Apalis iMX8

Errata Document

Figure 1. Location of C267 (top side, top view)

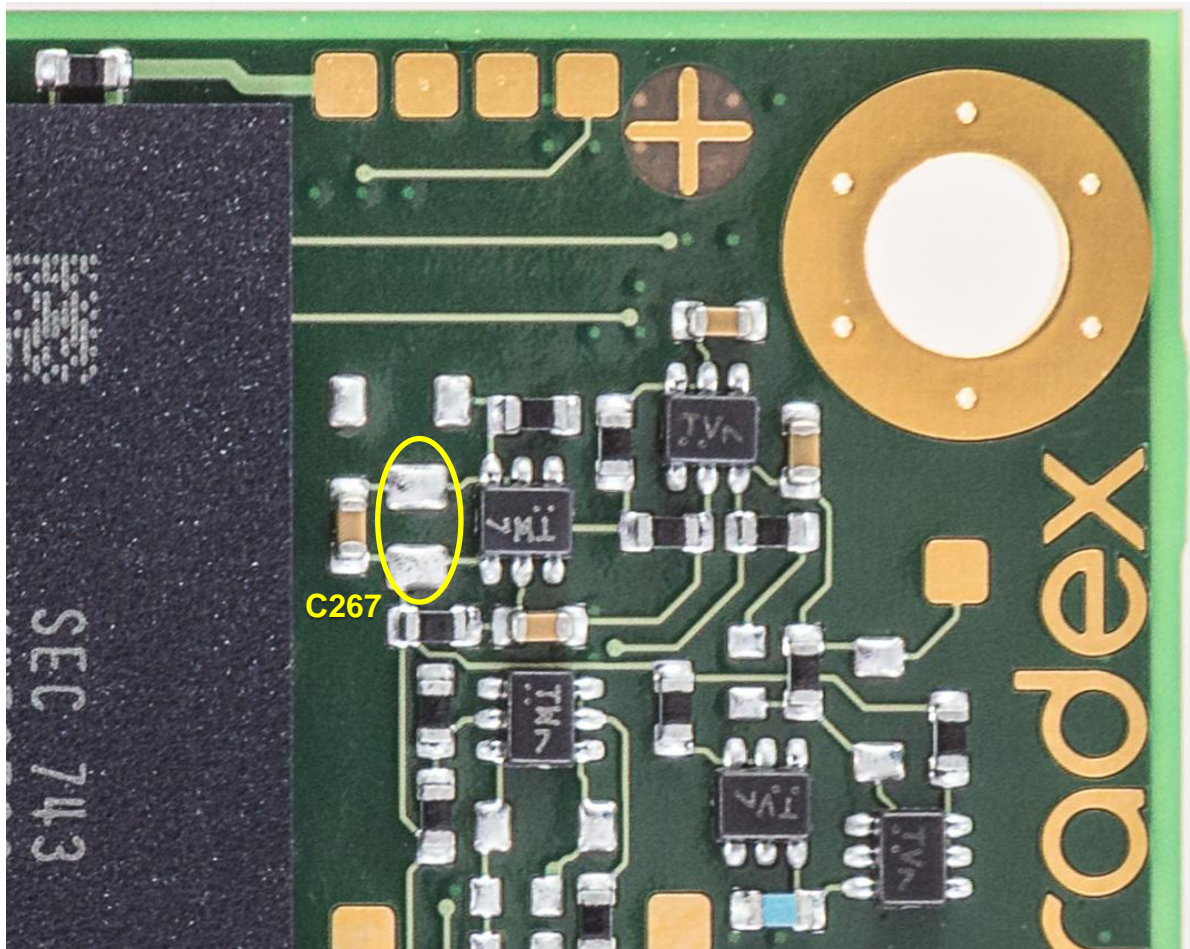
Unfortunately, the power button pulse that is generated is too short. The SoC does not get out of the power-off state, and therefore the PMIC is not turned on. The module does not start if the RTC rail is retained during the main voltage power cycle (VCC). The module can also not be started by pressing the reset button (RESET_MICO#). The only way to start the module after the PMIC is put to power-off is to remove the RTC rail together with the main module rail.

Option 2: Assemble C267 for making the power button signal pulse long enough. The capacitor C267 is not assembled on Apalis iMX8 modules with version 1.1A or older. By assembling C267 with a 10 μ F 6.3V capacitor with the 0603 size. The power button signal pulse gets its required duration. This means the module can be turned on either by power cycling VCC or by pressing the RESET_MICO# button

Figure 2. Proposed headphone capacitor discharge circuit

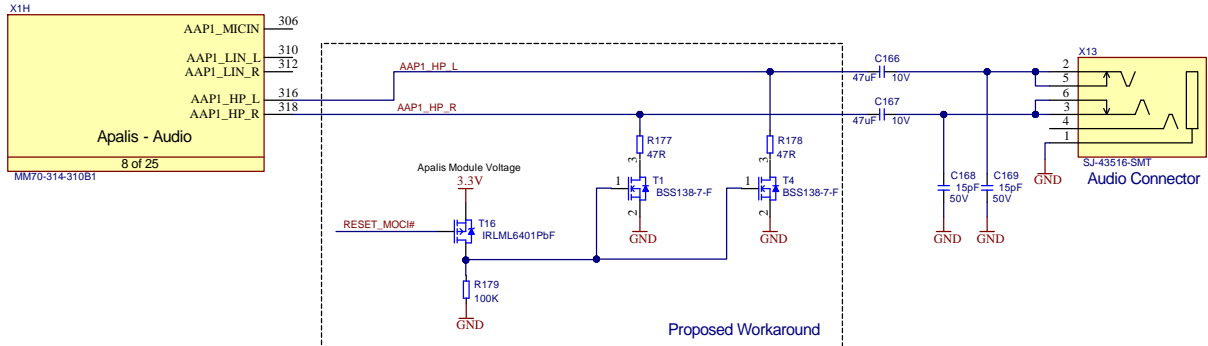
If headphones are plugged in during a software reboot, the voltage at the series capacitors is backfeeding to the power rails of the audio codec. The series capacitors are not fully discharged since the power rails are turned off only for around 5ms. The voltage at the 3.3V analog rail of the audio codec remains at about 1.5V. The residual voltage can cause the audio codec not to reset properly. This reset issue can prevent the audio codec from functioning properly. Power cycling the SoM resolves the problem.

If the audio codec needs to be reliably reset when used in combination with low-impedance headphones, an additional discharge circuit can be added to the carrier board. The idea behind this circuit is to discharge the series capacitors while the RESET_MOCI# signal is low. A resistor value of 47R is a good choice for series capacitors with values between 47 μ F and 100 μ F.
